**CITY OF NORTHGLENN**

**STORM DRAINAGE SYSTEM MAPPING AND CONDITION ASSESSMENT  
BID NO. 2023-006**

ADDENDUM NO. ONE TO BID 2023-006

DATED: April 4, 2023

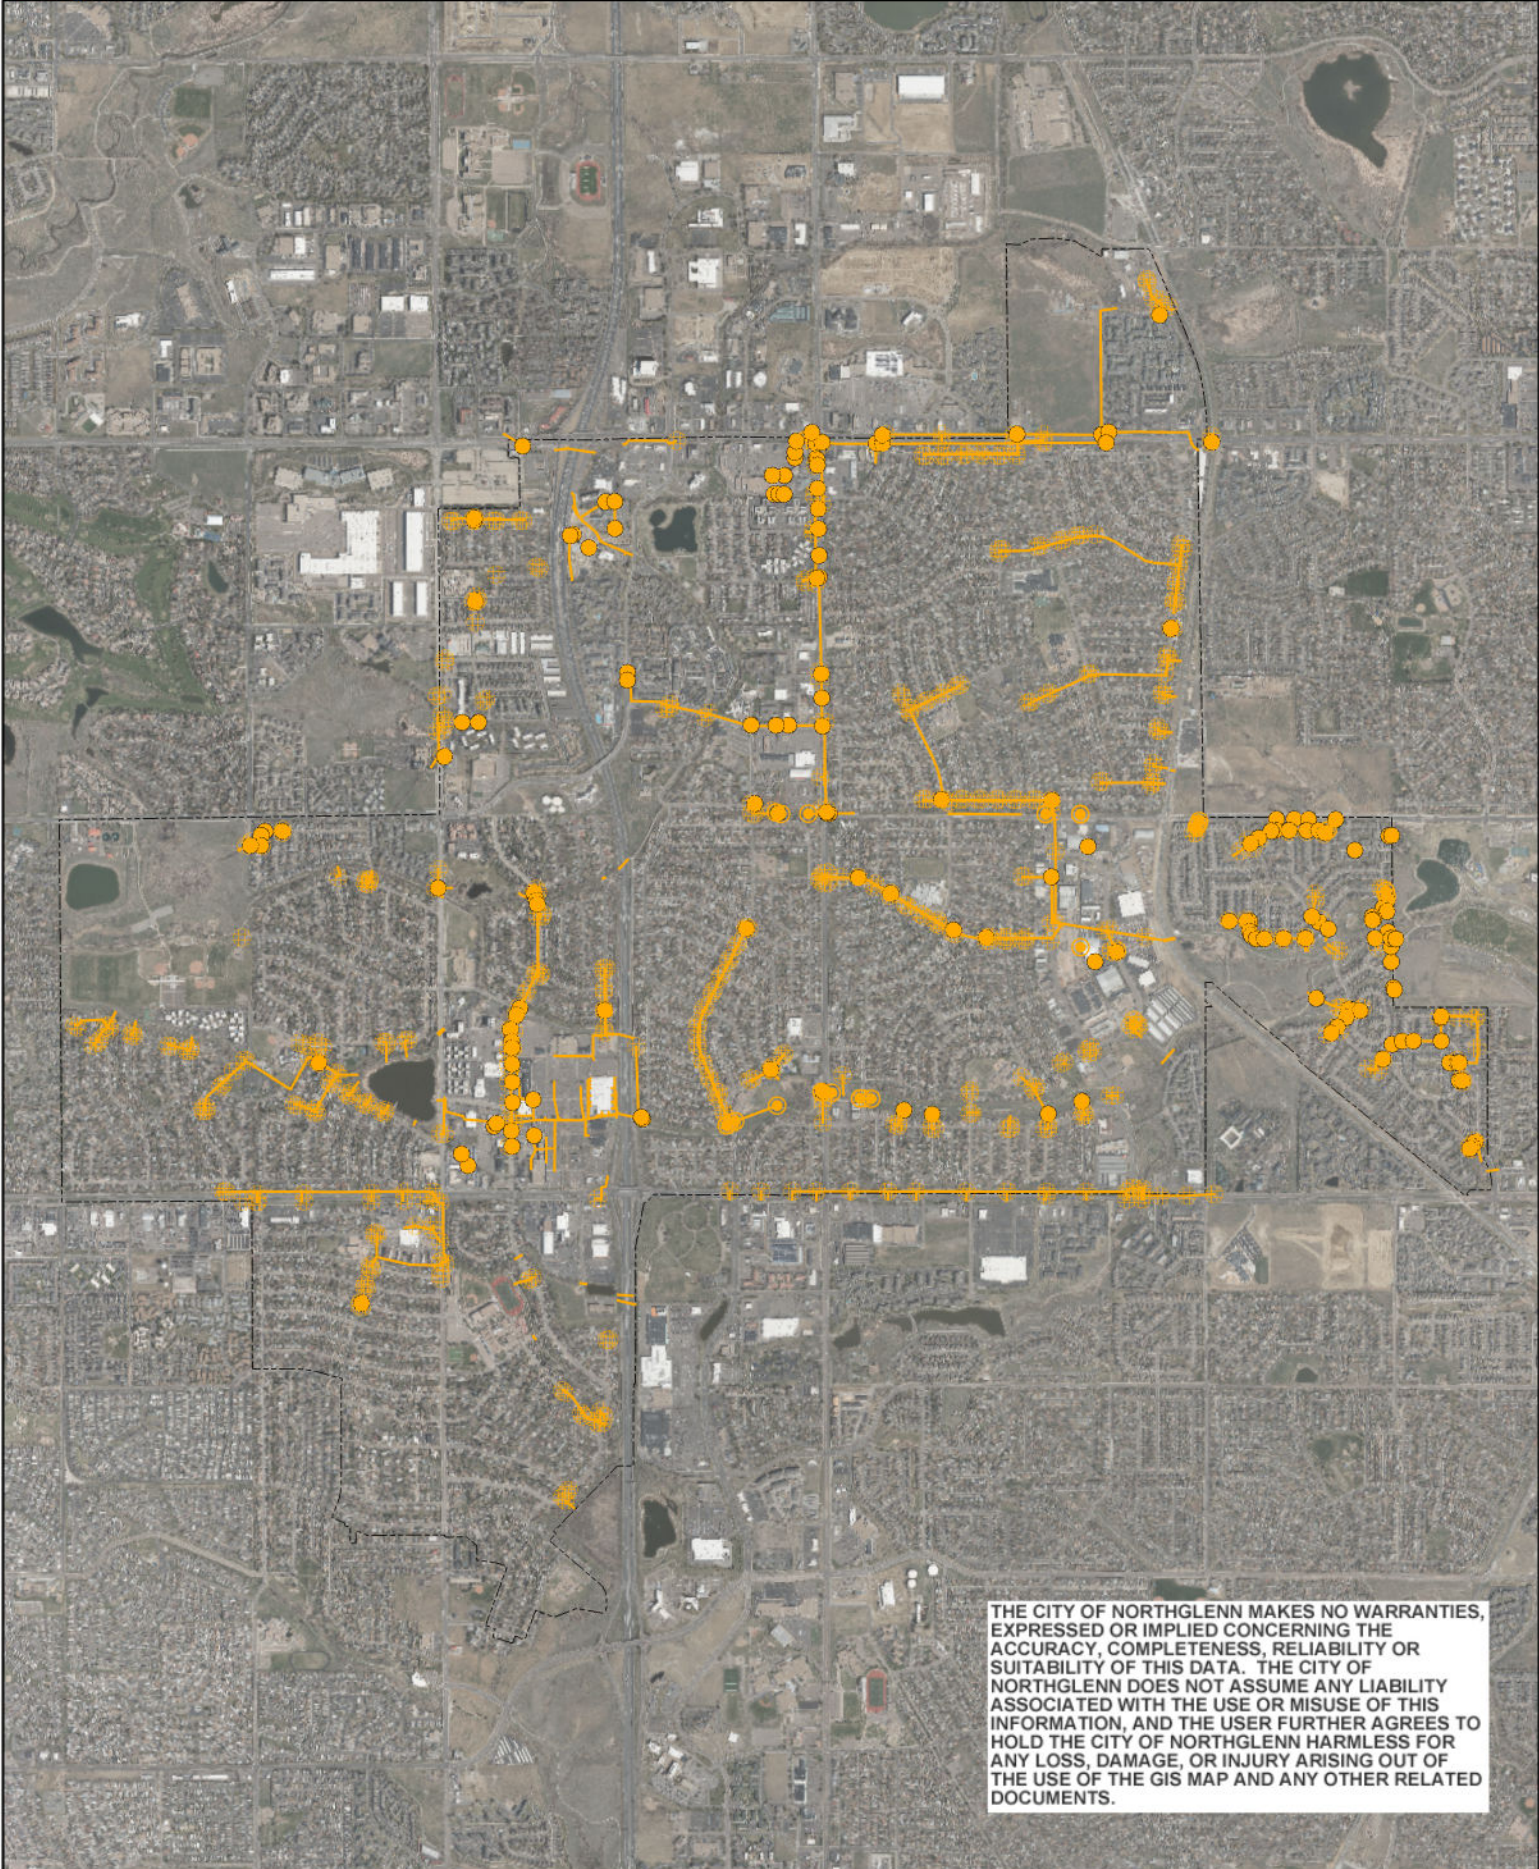
- 1) Are there plans for the project?
  - i. No construction plans. Project involves all of Northglenn system. An overview map of Northglenn's storm sewer system has been provided. *Attachment 1.*
- 2) Attachment A, Hourly Rates was not included with the RFP document.
  - i. Attachment A, Hourly Rates will be the proposers' rates.
- 3) Attachment B, Cert of Immigration Compliance was not included with the RFP document.
  - i. Our Finance Depart has informed me that this document is no longer required. This requirement to submit should be ignored.
- 4) Should Exhibit B, Amount of Compensation be submitted with proposal?
  - i. Yes.
- 5) What are the Evaluation Criteria for the proposals?
  - i. A copy of the Evaluation Criteria is provided in this Addendum. *Attachment 2.*
- 6) Is there a preferred format for References?
